Contract #: 04-0120F4Cty: SF/ALA Rte: 80 PM: 13.2/13.9File #: 69.25B**QUALITY ASSURANCE -- NON-CONFORMANCE REPORT****Location:** Changxing Island, Shanghai, P.R. China**Report No:** NCR-000460**Prime Contractor:** American Bridge/Fluor Enterprises, a JV**Date:** 05-Oct-2009**Submitting Contractor:** Zhenhua Port Machinery Company, Ltd (ZPMC), Changxing Island**NCR #:** ZPMC-0433**Type of problem:**

Reference Description: Third time repair without the Engineer's Approval**Description of Non-Conformance:**

Subject: NCR No. ZPMC-0433

REGARDING: NCR-000460(ZPMC-0433)

项目名称 Project Name	美国海湾大桥 SFOBB	部件图号 Drawing No	FB205	报告编号 Report No.	B-WR8094
合同号 Contract No.	04-0120F4	部件名称 Items Name	CB15 CROSS BEAM	NDT报告编号 Report No.of NDT	B787-UT-8945R1
项目编号 Project No.:	ZP06-787

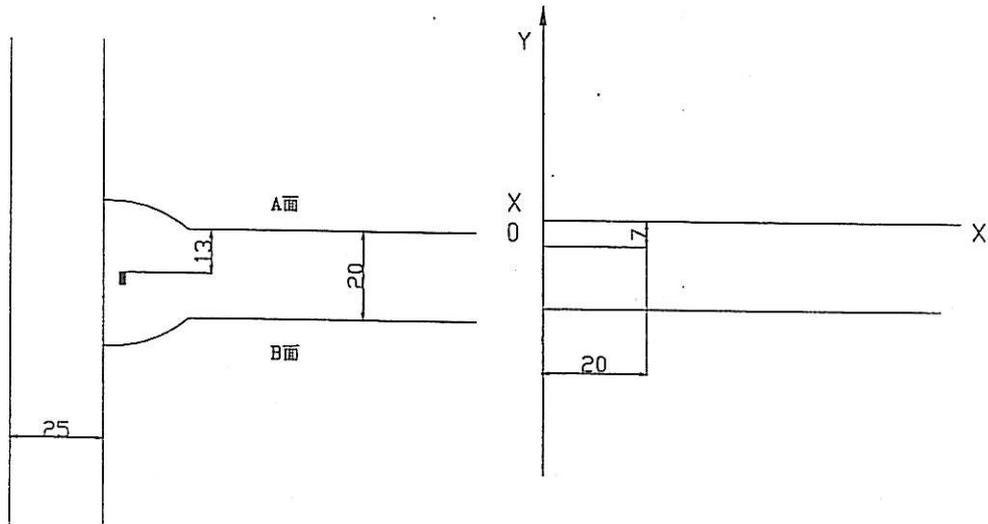
Rejected indication found by ultrasonic inspection is less than the maximum allowance aggregate length.

1. Did not clear the weld pass completely in time.

1. Gouge or grind from nearer side from metal edge ($D \leq 0.65T$, "D" is depth of defects, "T" is thickness of metal) to remove all defects;
2. Follow repair WPS for joint preparation, preheat, and weld deposit;
3. Verify with VT no defects remain in the weld joint prior to welding;
4. Grind the repaired area flush with base metal or the adjacent weld;
5. Check the welds according to the working drawings.

项目名称 Project Name:	美国海湾大桥 SFOBB	部件图号 Drawing No.:	FB205	报告编号 Report No.:	B-CWR852
合同号 Contract No.:	04-0120F4	部件名称 Item Name:	CB15 CROSS BEAM	NDT 报告编号 NDT Report No.:	B787-UT-8945R2
项目编号 Project No.:	ZP06-787

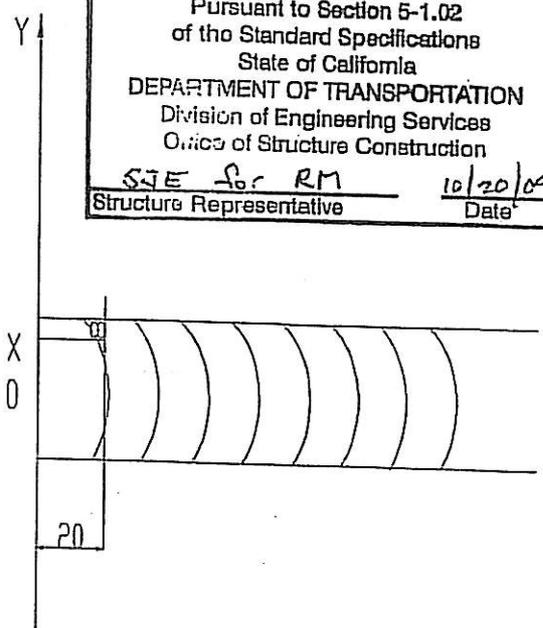
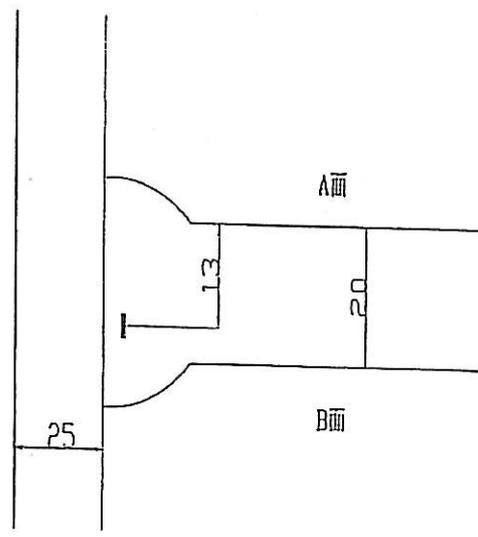
A Rejectable indication was found by Ultrasonic Inspection for a third repair.
(UT三次缺陷) FB205-045-013

1. 焊工在第一次反面清根时, 没有注意, 导致焊接缺陷没有全部去除;
2. 在焊返修前, QC没有确认所有的焊接缺陷已经去除。
1. The welder was not observant during the first backgouging operation resulting in the Indications not being completely removed.
2. QC did not verify the indications had been removed prior to re-welding.

1. QC and a Lead CWI shall be present and monitor all gouging, grinding and welding operations during this repair.
2. QC shall have a copy of the CWR available to ensure the repair is per the disposition requirements.
3. If gouging is performed, preheat per the repair WPS minimum requirements.
4. Gouge and/or grind to remove all the defects from the Face A.
5. Prepare the repair joint according to the relevant repair WPS.
6. Grind area smooth to a shiny finish.
7. Perform VT and MT to ensure the defects have been removed.
8. Preheat and weld according to the relevant repair WPS.
9. Perform VT, MT and UT to the repair areas.
10. Grind the weld flush with the adjacent weld.
- ~~11. Check the weld according to the working drawings.~~ *REMOVE*

PERFORM NAT AFTER GRINDING FLUSH

项目名称 Project Name	美国海湾大桥 SFOBB	部件图号 Drawing No	FB204	报告编号 Report No.	B-WR8098
合同号 Contract No.	04-0120F4	部件名称 Items Name	CB15 CROSS BEAM	NDT报告编号 Report No.of NDT	B787-UT-8945R1
项目编号 Project No.:	ZP06-787

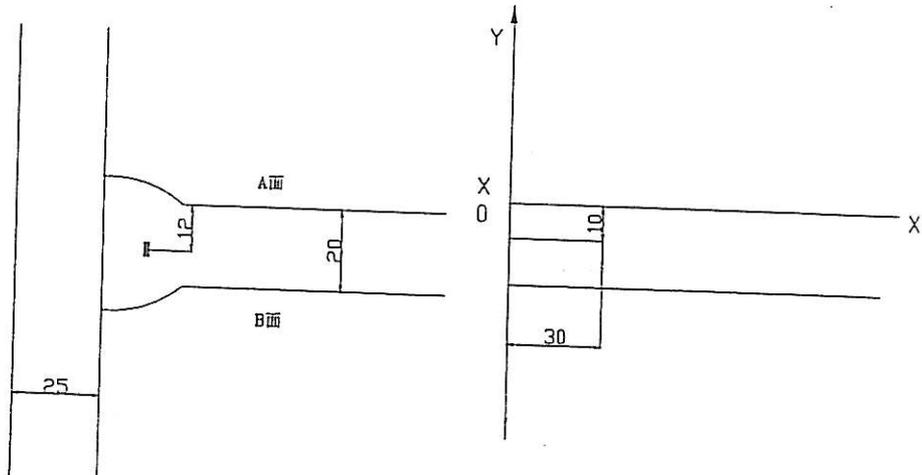
Rejected indication found by ultrasonic inspection is less than the maximum allowance aggregate length.

1. Did not clear the weld pass completely in time.

1. Gouge or grind from nearer side from metal edge ($D \leq 0.65T$, "D" is depth of defects, "T" is thickness of metal) to remove all defects;
2. Follow repair WPS for joint preparation, preheat, and weld deposit;
3. Verify with VT no defects remain in the weld joint prior to welding;
4. Grind the repaired area flush with base metal or the adjacent weld;
5. Check the welds according to the working drawings.

项目名称 Project Name:	美国海湾大桥 SFOBB	部件图号 Drawing No.:	FB204	报告编号 Report No.:	B-CWR856
合同号 Contract No.:	04-0120F4	部件名称 Item Name:	CB15 CROSS BEAM	NDT 报告编号 NDT Report No.:	B787-UT-8945R2
项目编号 Project No.:	ZP06-787

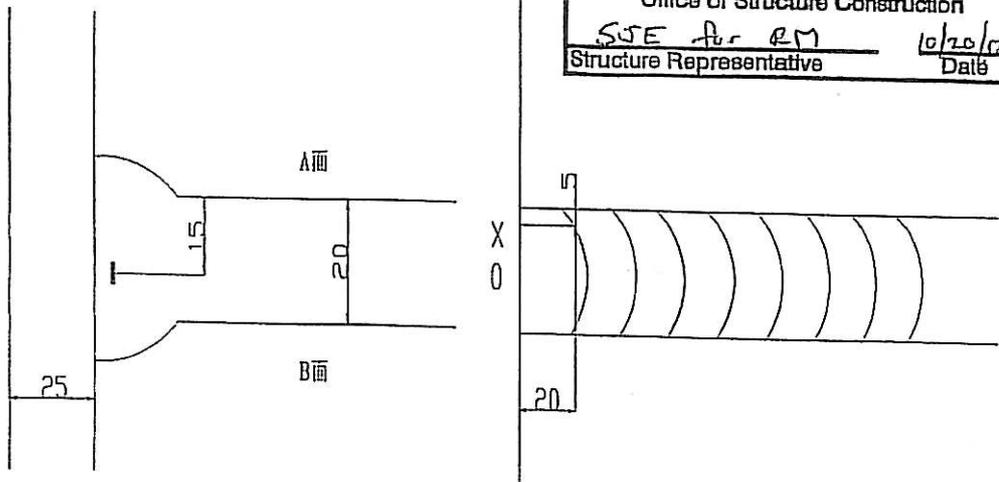
A Rejectable indication was found by Ultrasonic Inspection for a third repair.
(UT三次缺陷) FB204-047-009

1. 焊工在第一次反面清根时, 没有注意, 导致焊接缺陷没有全部去除;
2. 在焊返修前, QC没有确认所有的焊接缺陷已经去除。
1. The welder was not observant during the first backgouging operation resulting in the Indications not being completely removed.
2. QC did not verify the indications had been removed prior to re-welding.

1. QC and a Lead CWI shall be present and monitor all gouging, grinding and welding operations during this repair.
2. QC shall have a copy of the CWR available to ensure the repair is per the disposition requirements.
3. If gouging is performed, preheat per the repair WPS minimum requirements.
4. Gouge and/or grind to remove all the defects from the Face A.
5. Prepare the repair joint according to the relevant repair WPS.
6. Grind area smooth to a shiny finish.
7. Perform VT and MT to ensure the defects have been removed.
8. Preheat and weld according to the relevant repair WPS.
9. Perform VT, MT and UT to the repair areas.
10. Grind the weld flush with the adjacent weld.
- ~~11. Check the weld according to the working drawings. REMOVE~~

PERFORM NAT AFTER GRINDING FLUSH
